REFERENCE: RECON 25/0909

PROPOSAL: 5NO. FLATS, PARKING, LANDSCAPING AND ASSOCIATED WORKS

SITE: The Old Post Office 2 Tregarn Road Langstone NP18 2JS

APPLICATION TYPE: S73 to vary conditions of 23/0418

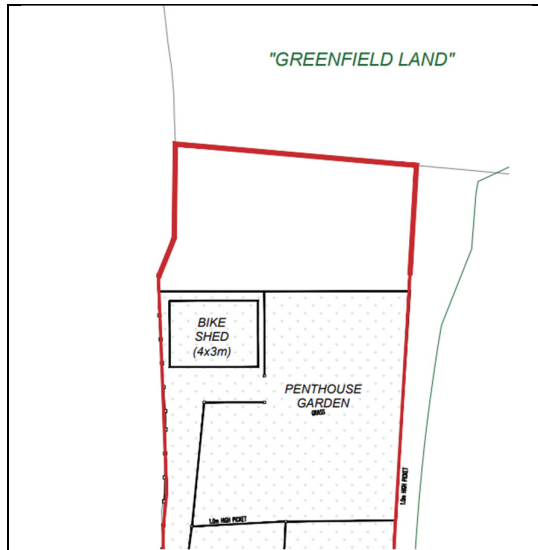
The highway frontage is now confirmed as a low wall with planting at just above ground level which is a welcome change. Note the continuous block paving under planting areas will require removal. I understand there are highway constraints regarding planting height at the frontage, ideally pedestrian splays should be shown.

There is **scope for taller planting within the grass area** away from the frontage and for this area to incorporate small trees which will break up views of the main elevation - leaving this to grass is insufficient.
